# SITE DEVELOPMENT PLAN DORSEY CENTER APARTMENTS, PARCEL 'T' 1ST ELECTION DISTRICT HOWARD COUNTY, MARYLAND

PLEASE NOTE THAT THIS REVISION SUPERSEDES AND REPLACES THE NOVEMBER 2020 BEI PLAN SHEET.

| TITLE: DETAILED GRADING AND ACCESSIBILITY PLAN   |            |   |  |

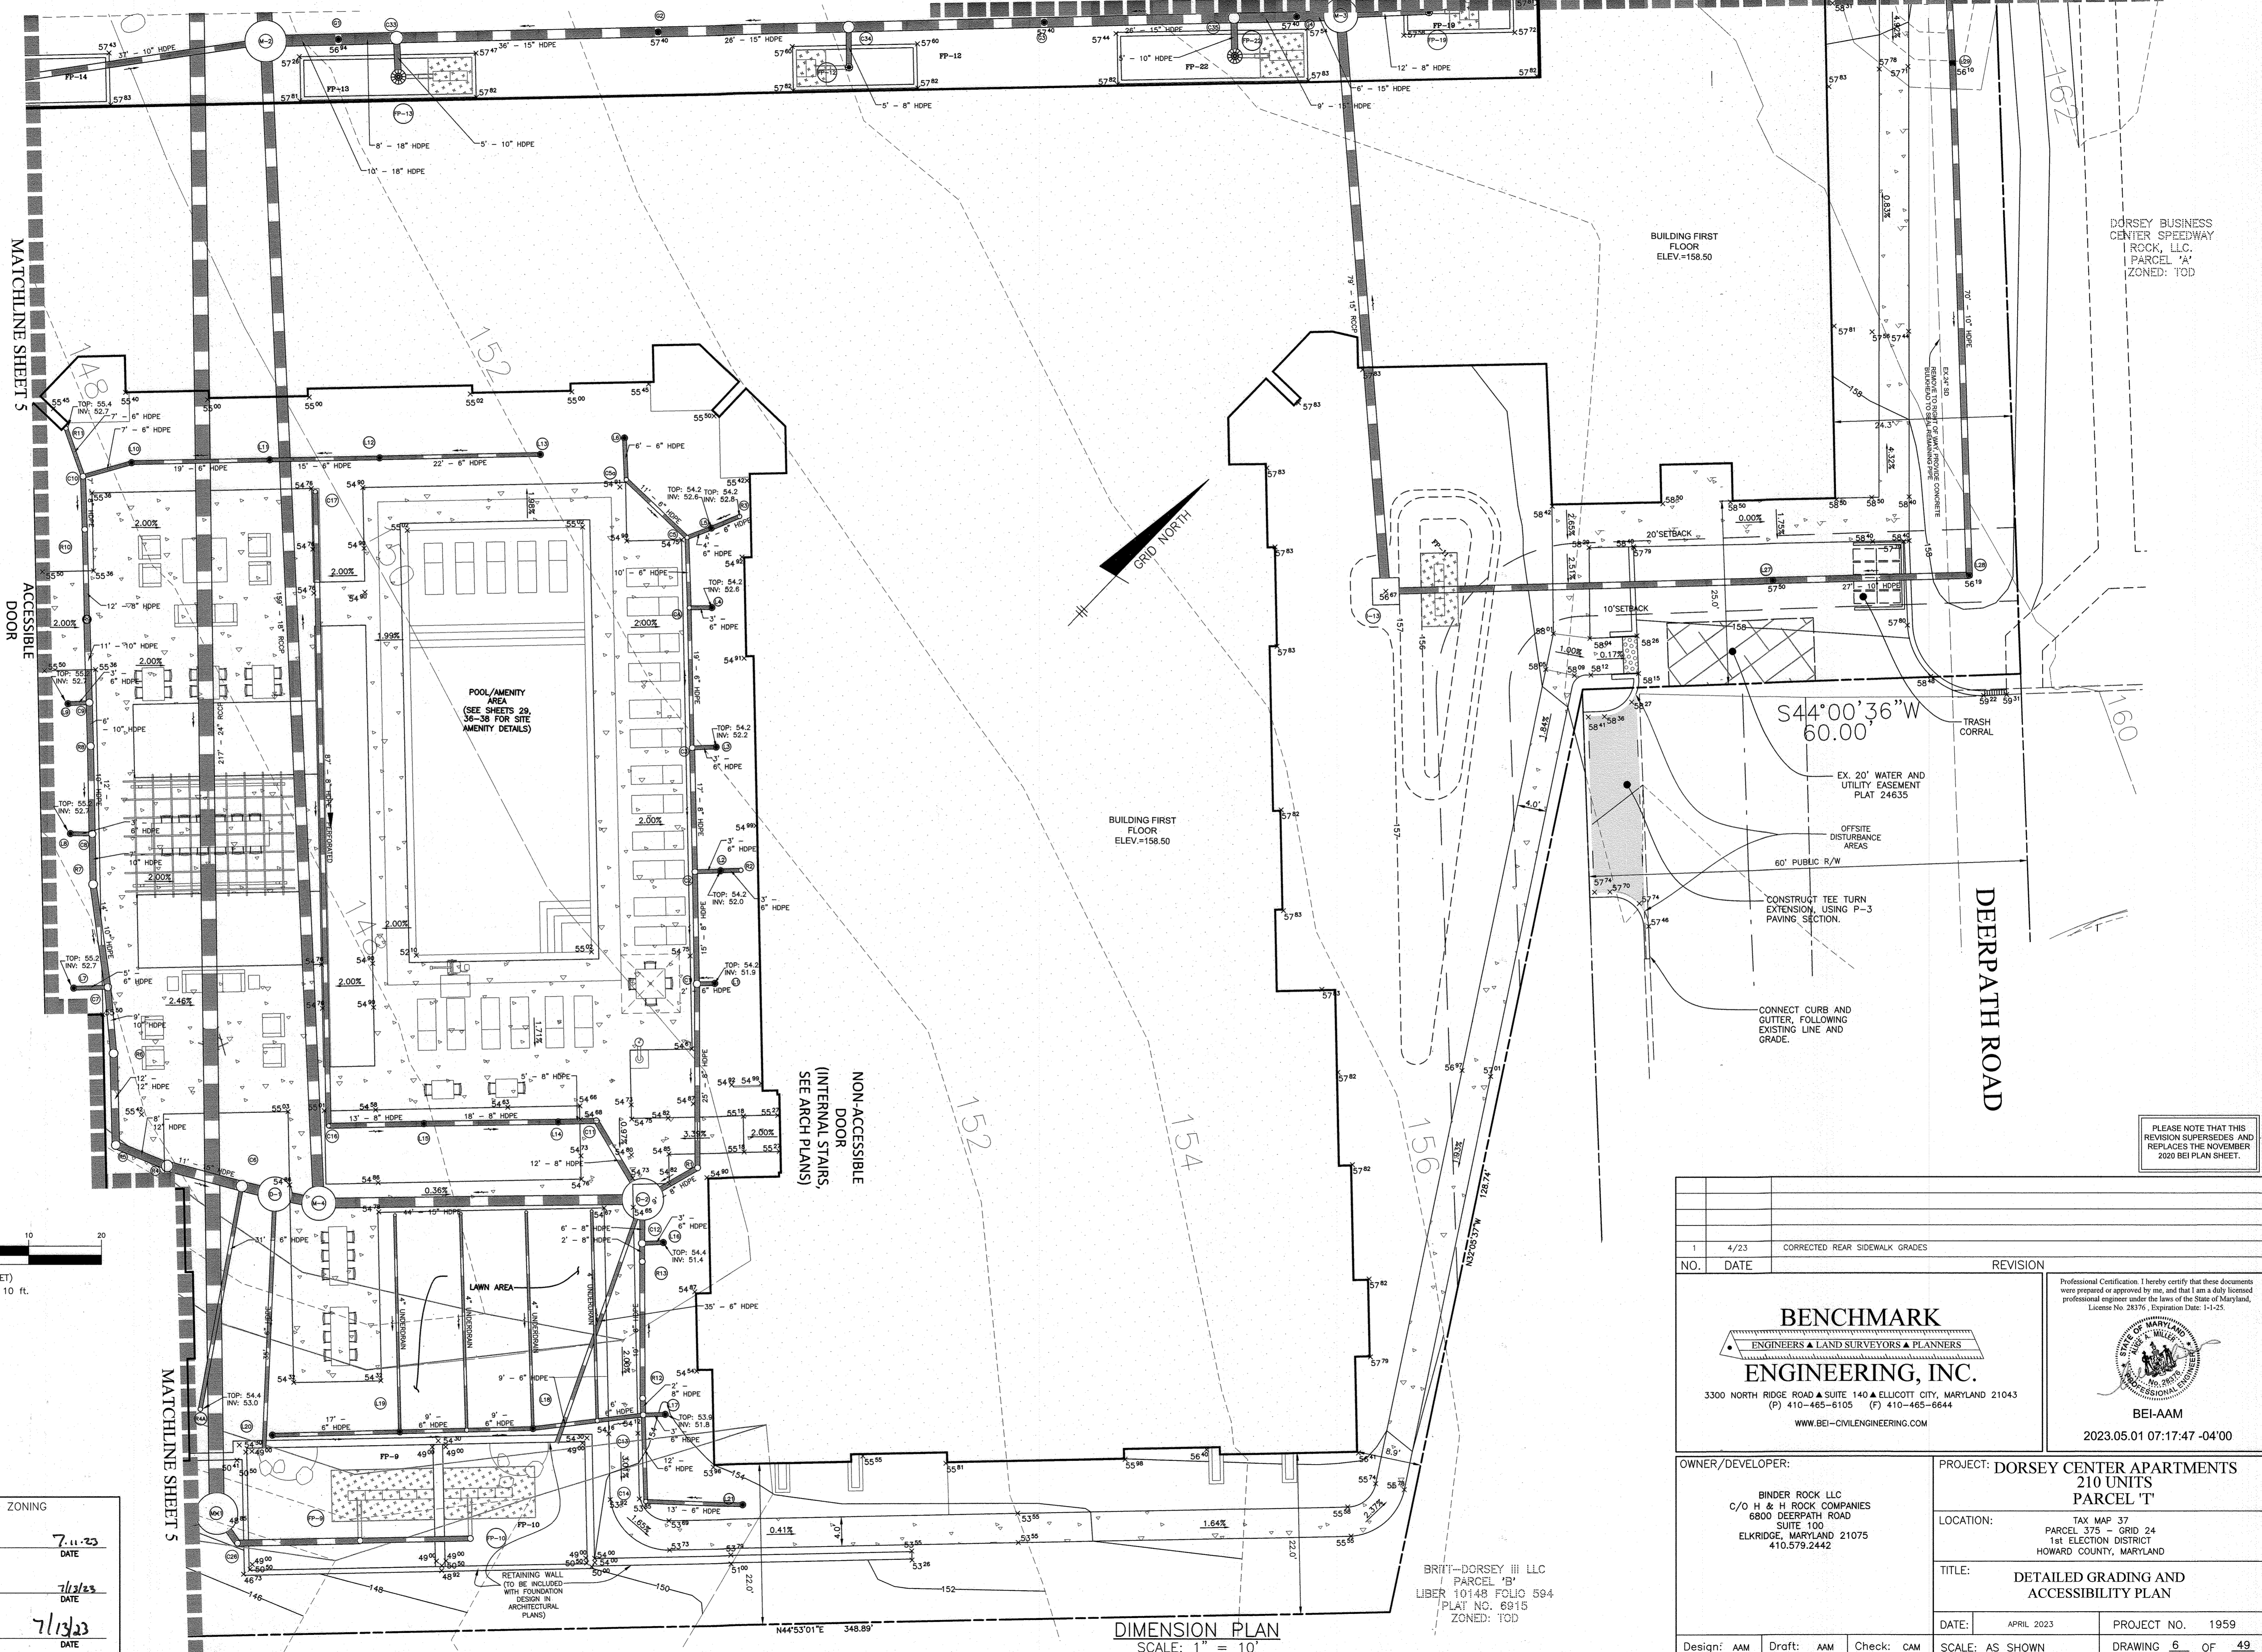
| 1  |            | 4/23  | REVISED SOUTH FRONT SIDEWALK LAYOUTS, WHC LOCATION AND FDC LOCATION. |

TITLE: REVISED GRADING, SEDIMENT AND EROSION CONTROL PLAN, NOTES AND DETAILS

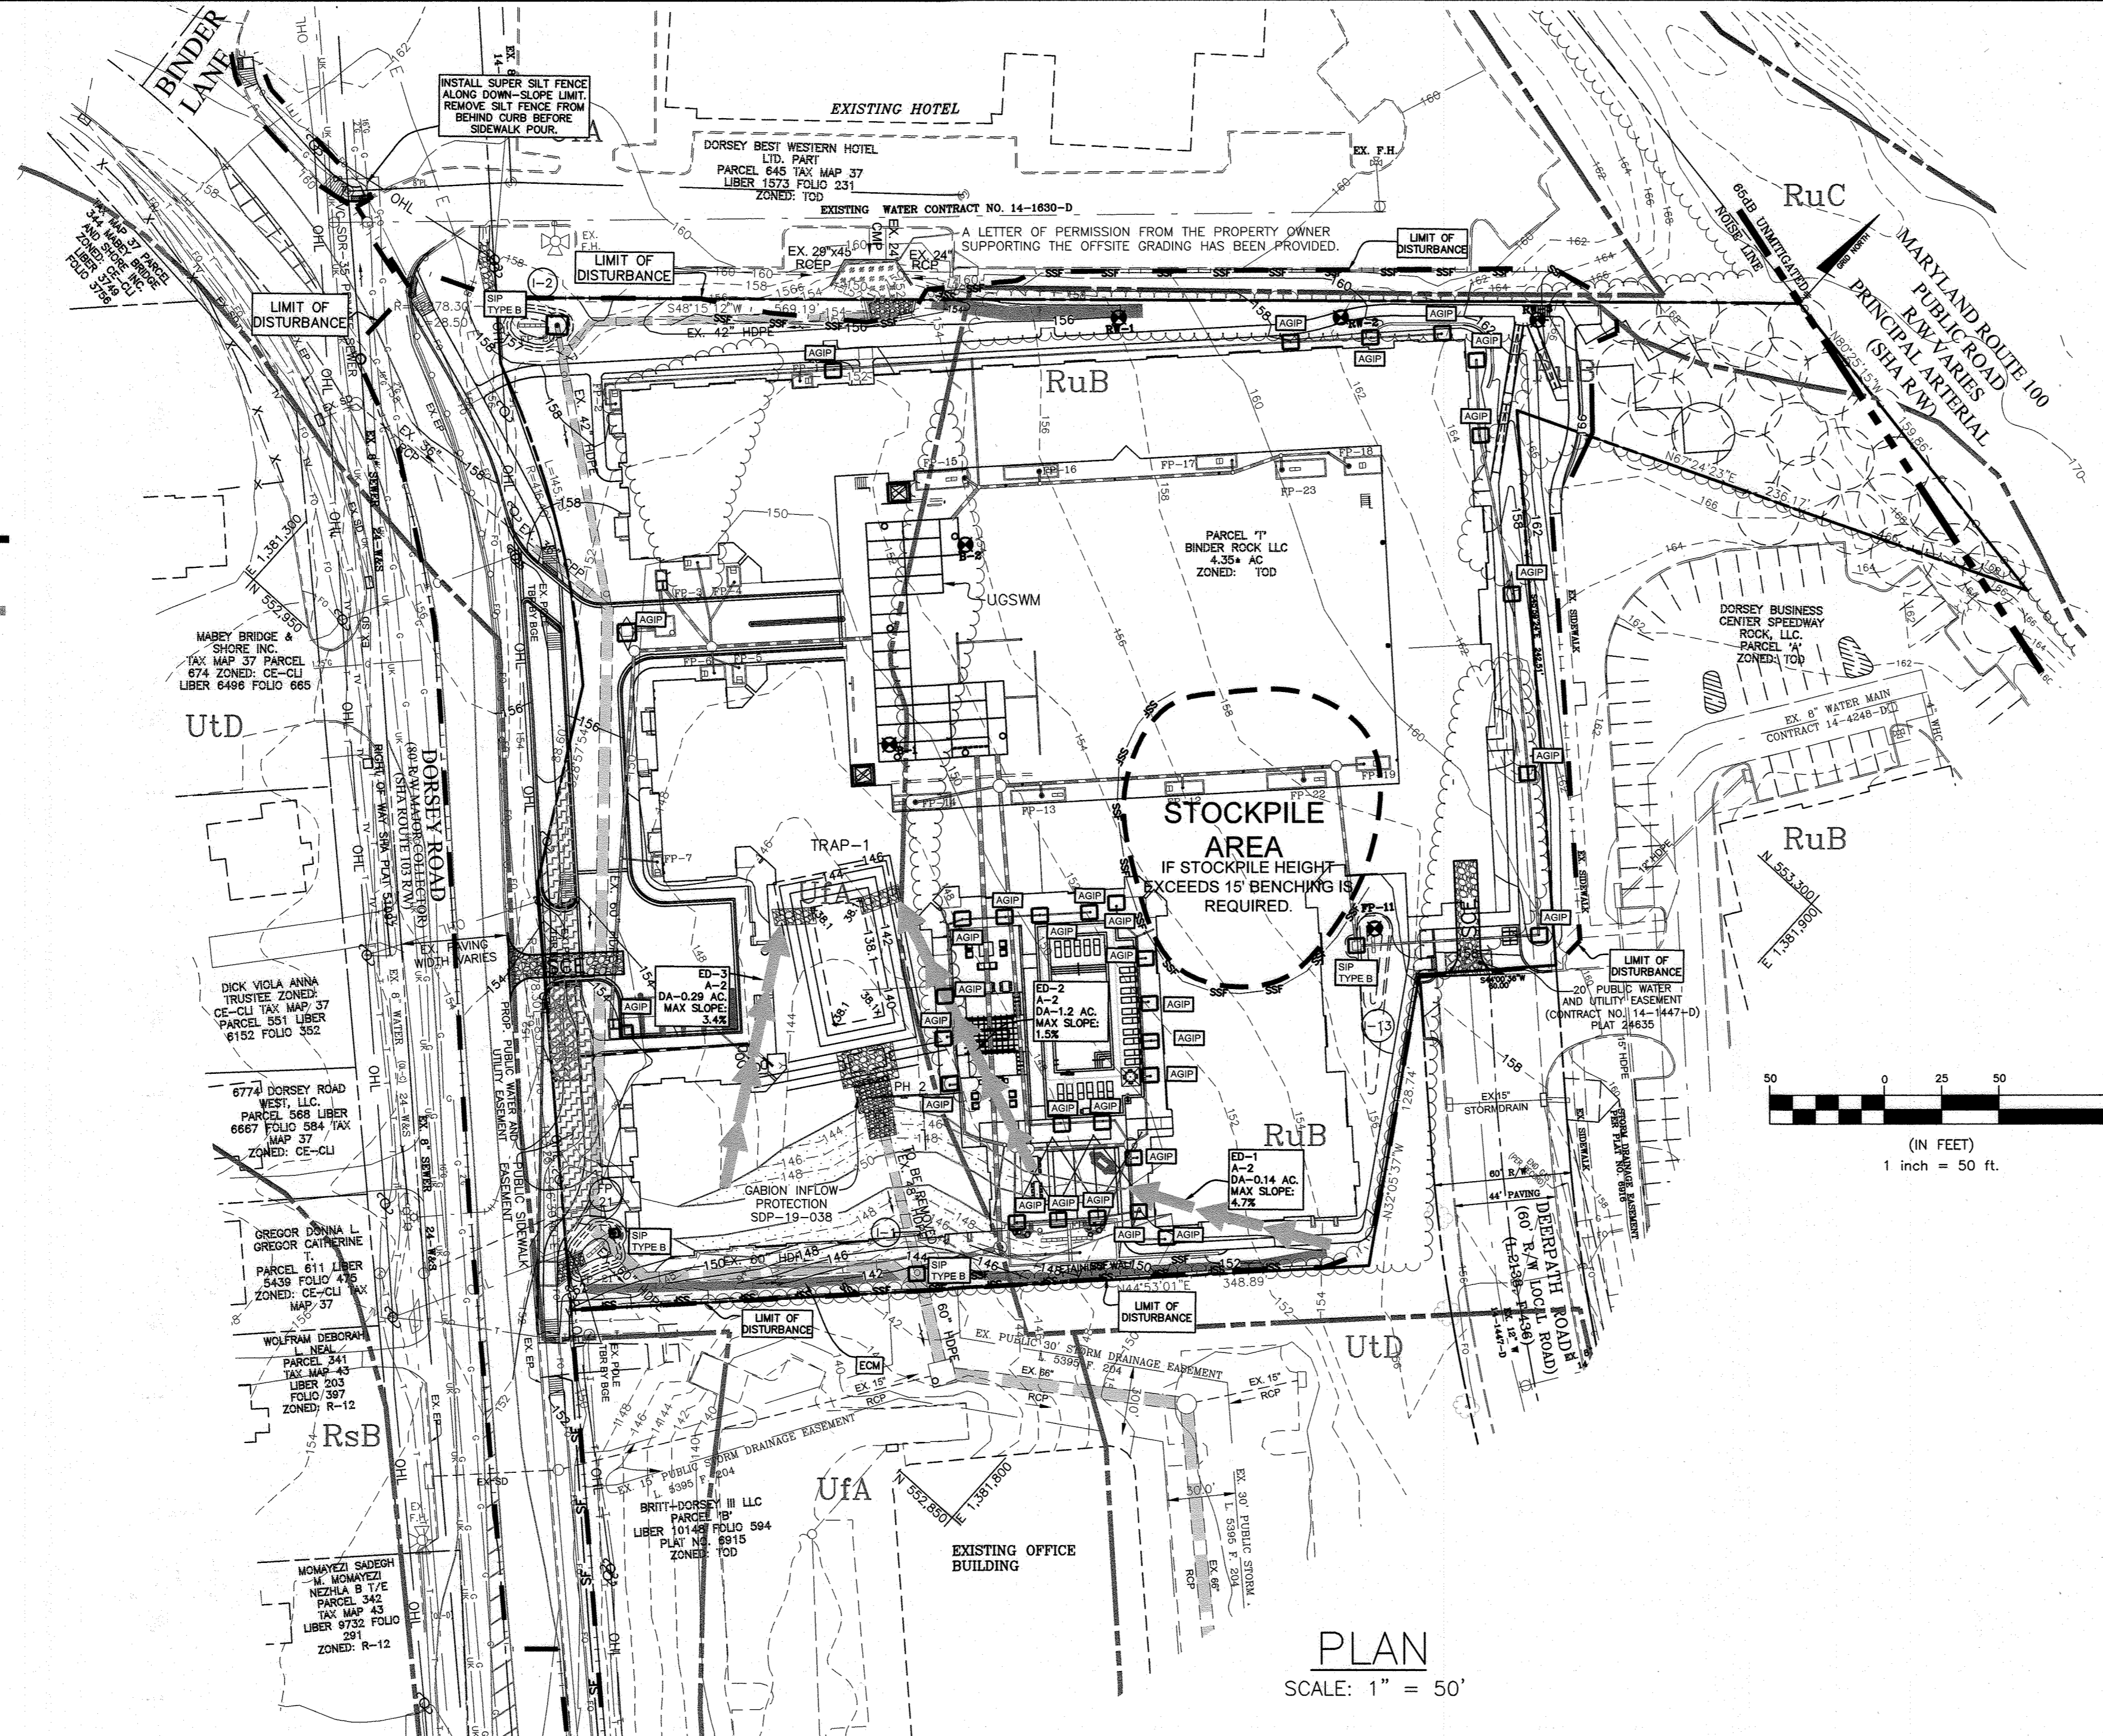
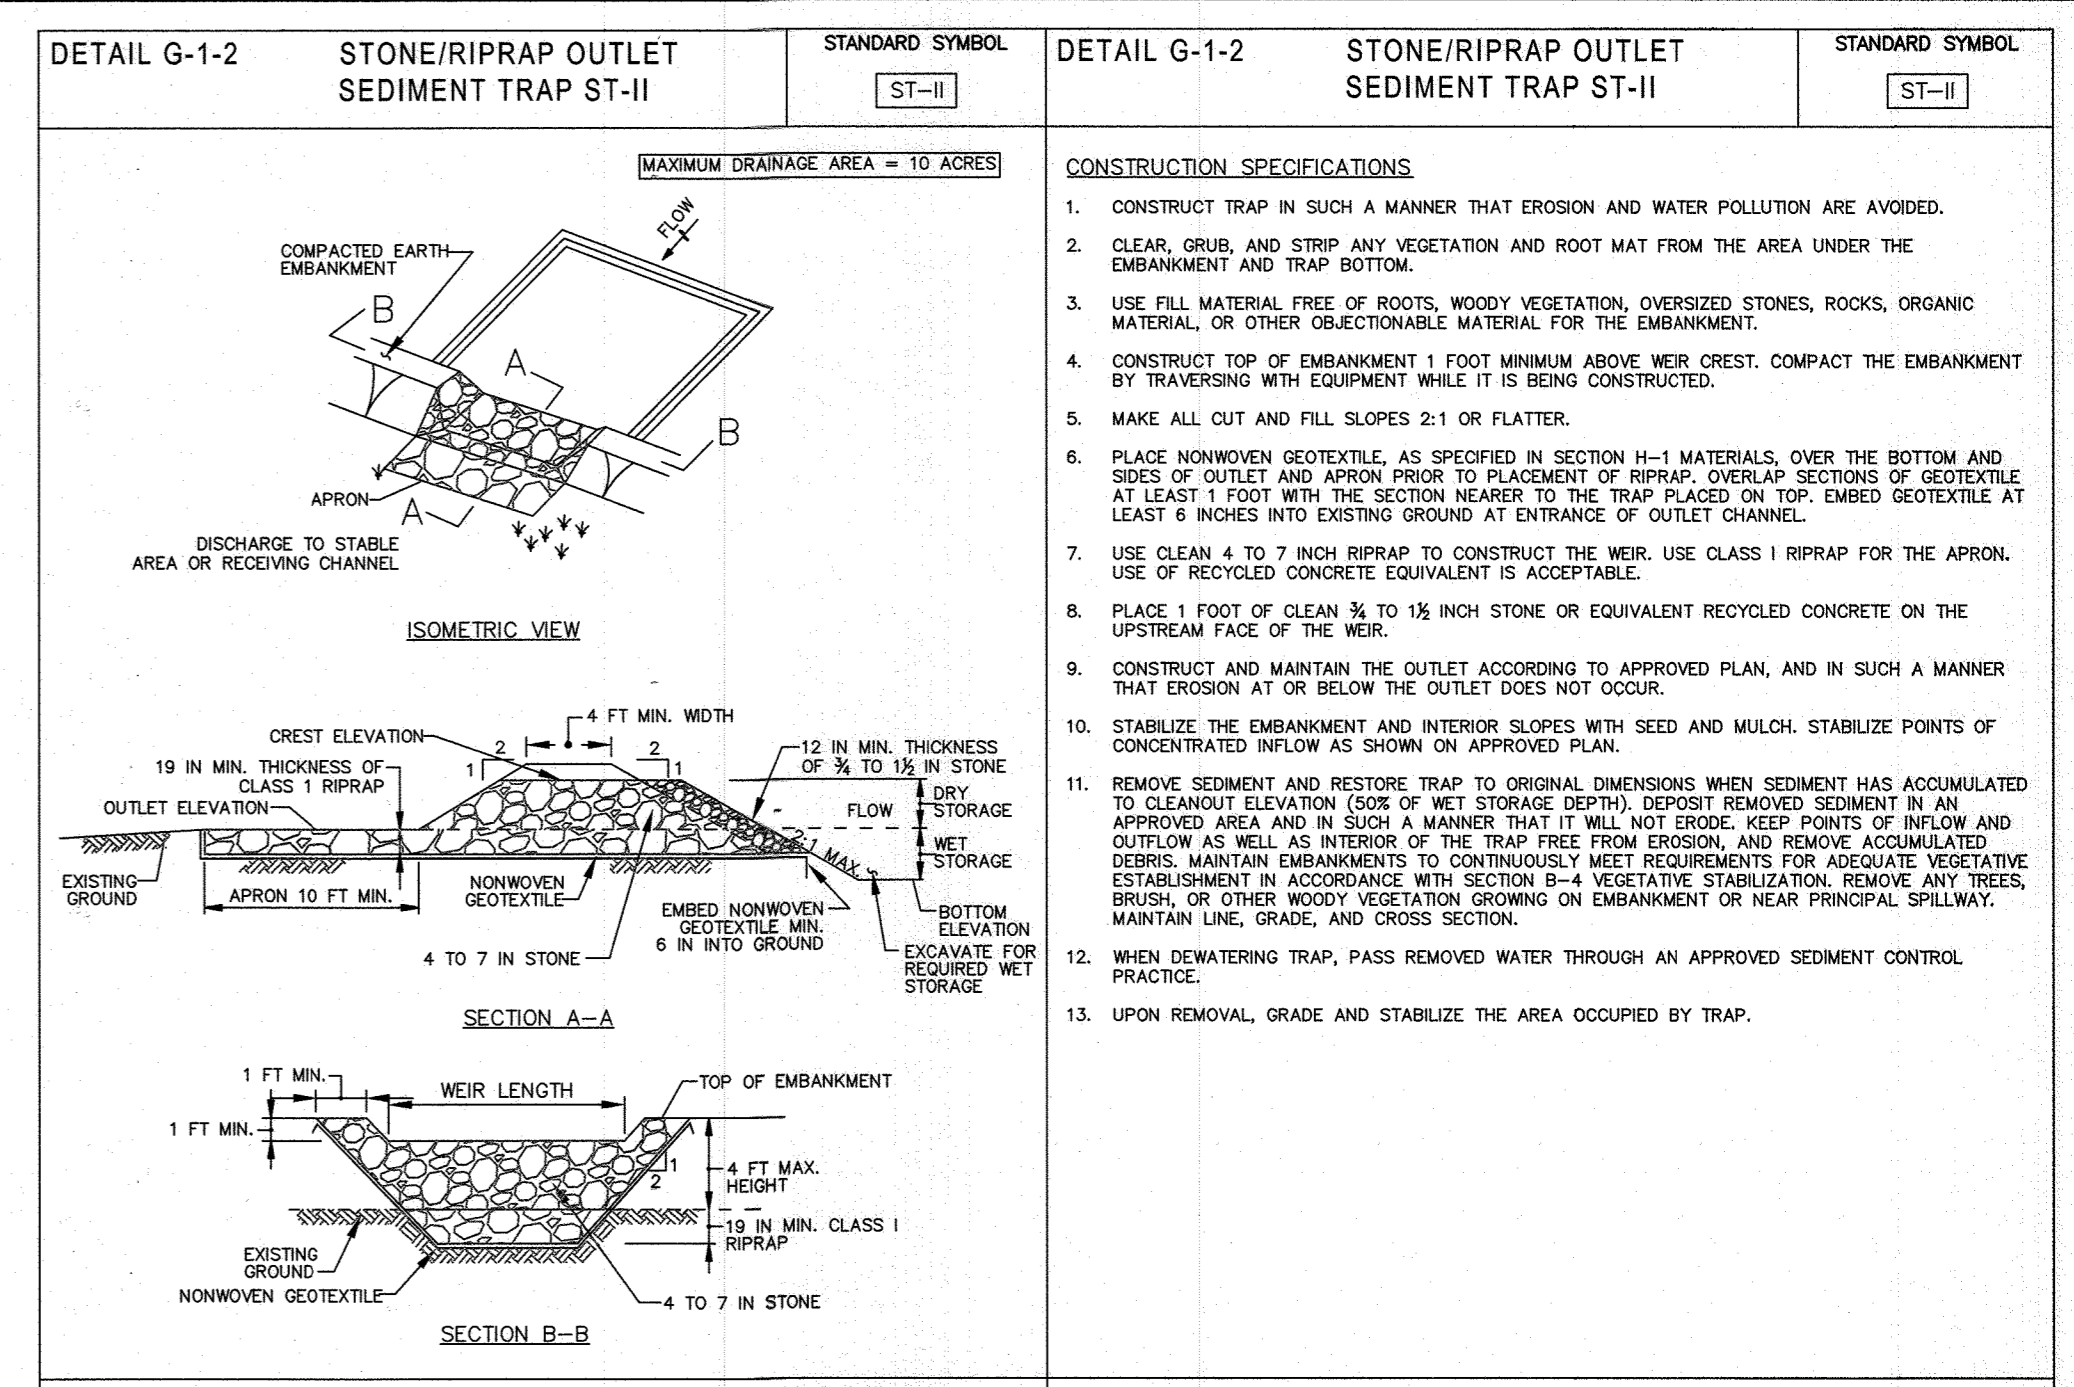
| NO. | DATE | REVISION   |
|-----|------|--|
| 1   | 4/23 | REVISED INLET PROTECTION LOCATION TO MATCH REVISED LANDSCAPE DRAINS, AND SHOW REVISED AND OFFSITE GRADING. |
